Application Number P24-02

**P24-02**  
**Lake Road Warehouse**

Property Owner: Carl and Connie Schoen  
Applicant: Titus Miller  
Location: 1041 Lake Road  
Zoning: I-1 (Industrial)  
Request: Site Plan approval for the construction of a warehouse

**PRELIMINARY SITE PLAN**

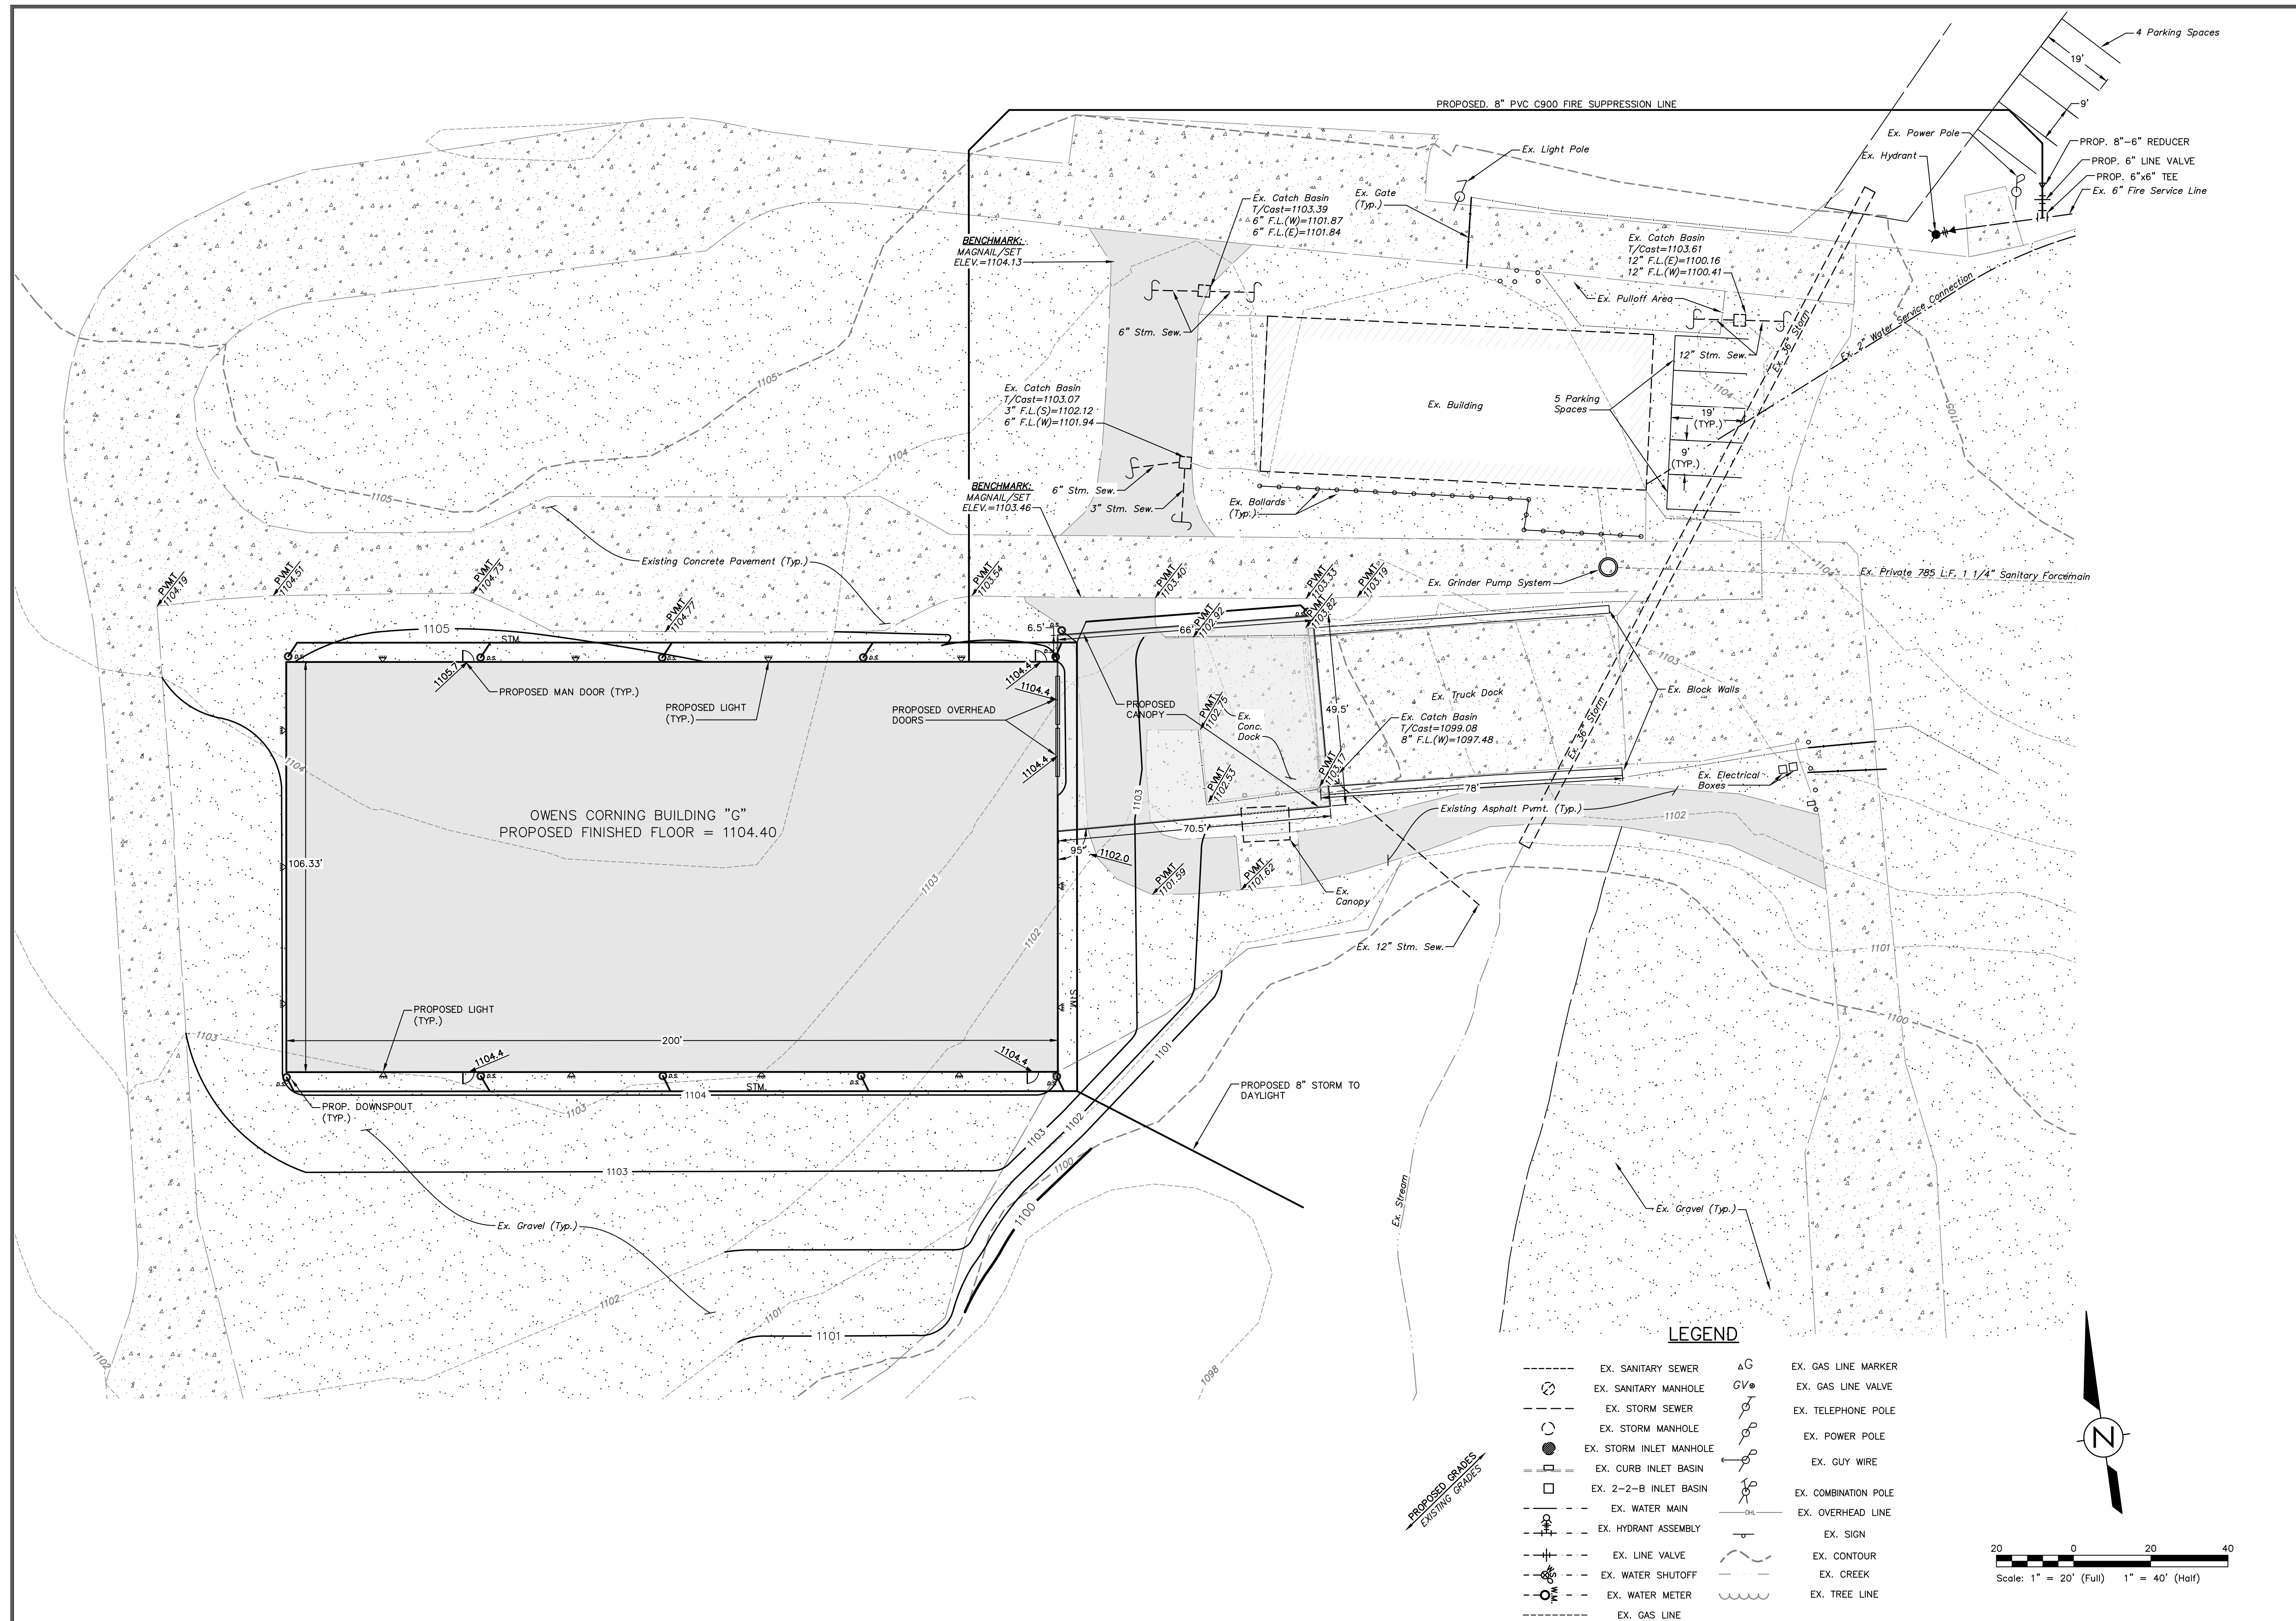
The site has access to public water and sanitary sewer service. An existing storm water basin appears to be located to the south of the proposed warehouse.

The Engineering Department has indicated that a storm water management and sediment control analysis will be required.

The Fire Department has noted that the applicant will need to work with the department regarding the proposed fire suppression line, the location of the fire department connection, and possibly installing an additional fire hydrant.

Lighting must comply with Section 1145.09(c) including a photometric plan, full cut-off fixtures, and a maximum lighting height of 25 ft. The proposed plan shows wall pack lights on all sides of the building. A light detail will need to be provided incorporating full cut-off fixtures.

- (1) A lighting detail shall be provided incorporating full cut-off fixtures.
- (2) A storm water management and sediment control analysis shall be completed as required by the City Engineer.

NORTH ELEVATION  
SCALE - 1/10" = 1'-0"

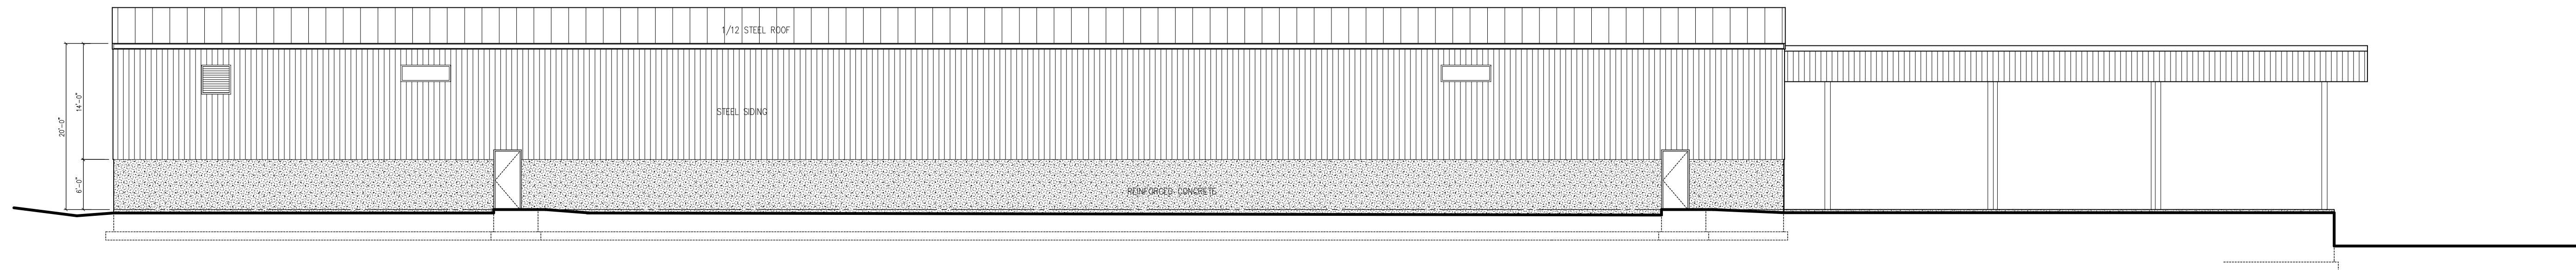
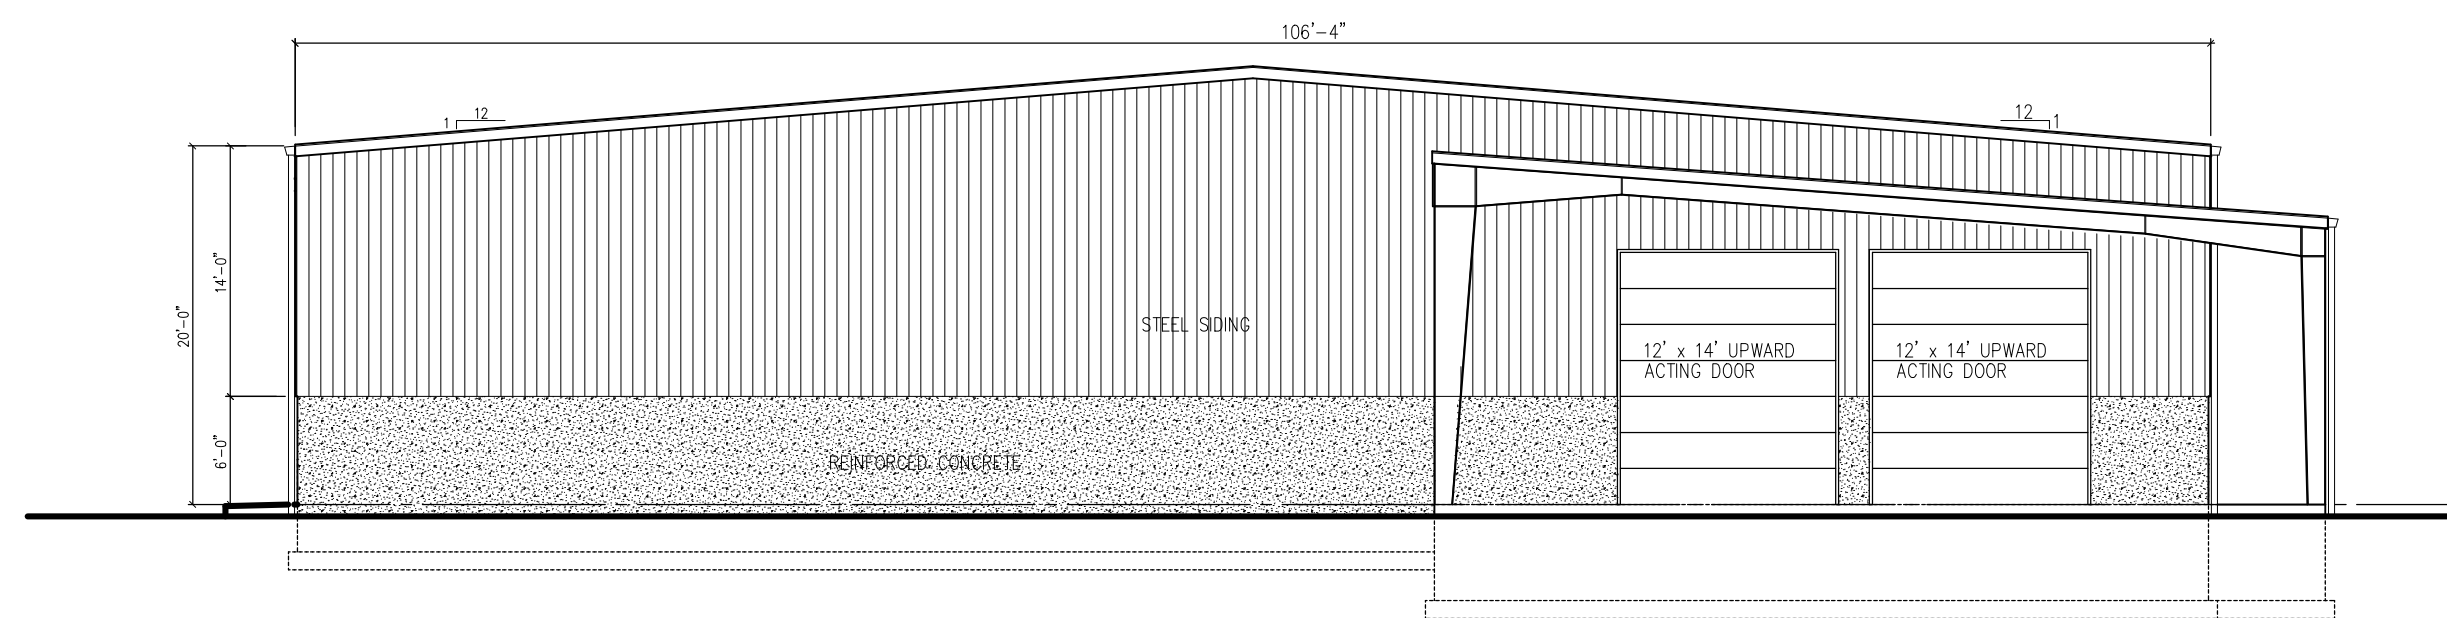
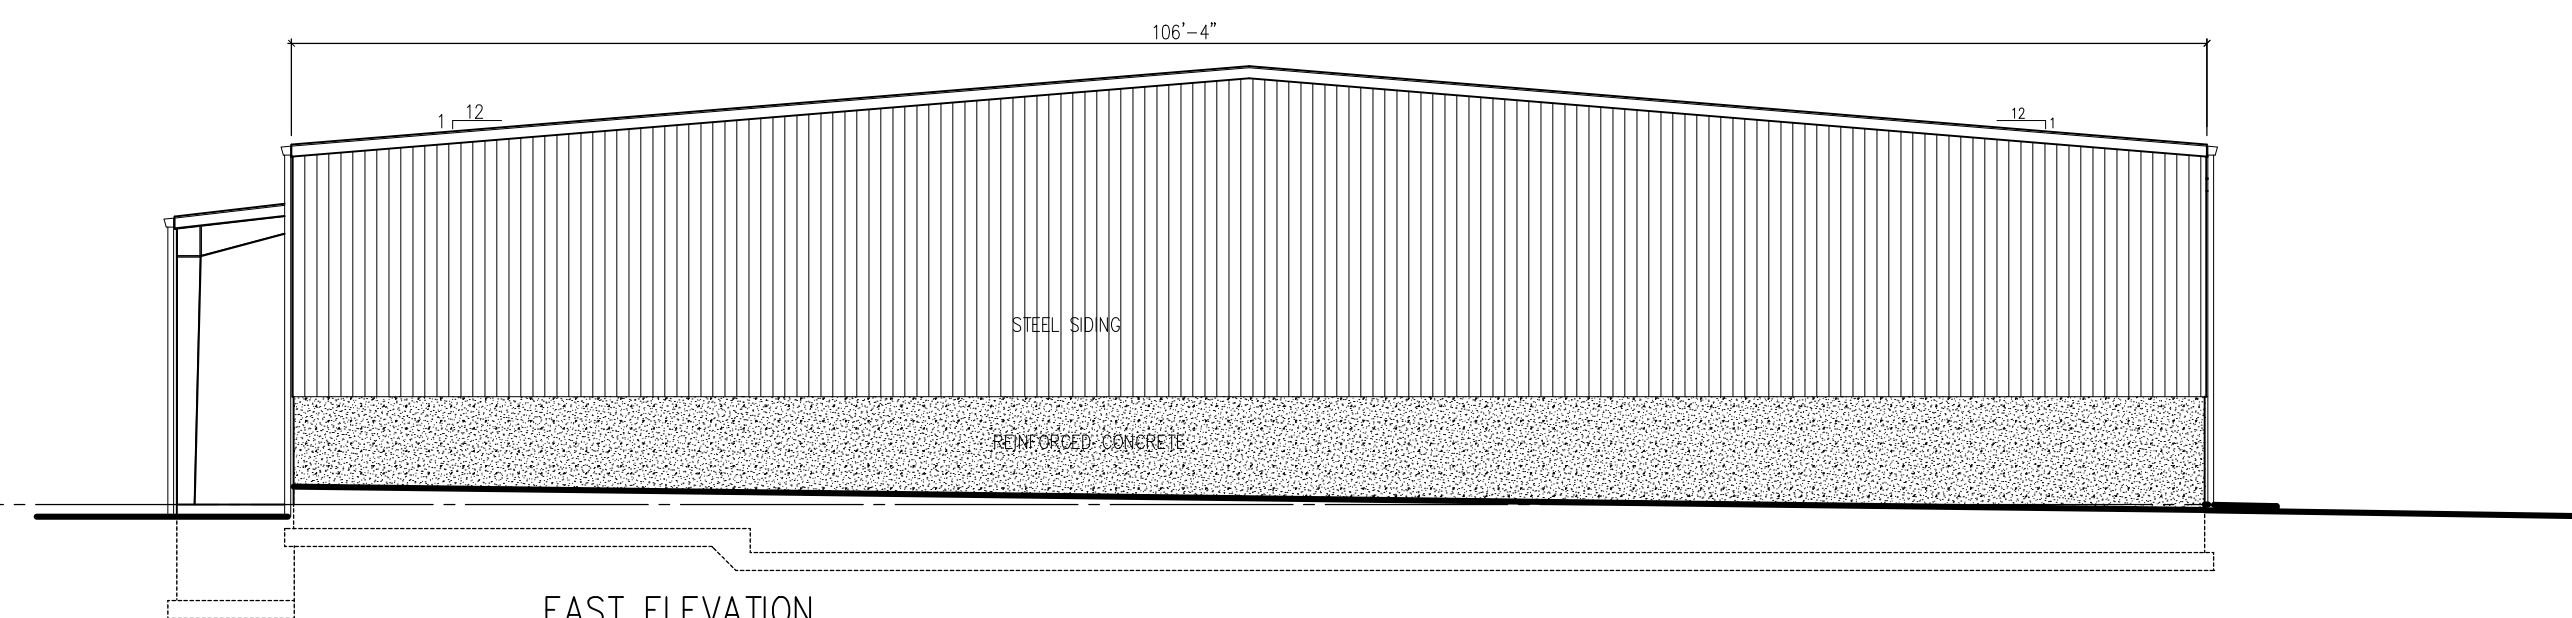
The proposed warehouse building includes a 6 ft. poured concrete lower section, a metal upper section, and metal roofing. The east side of the building includes a canopy and loading doors.
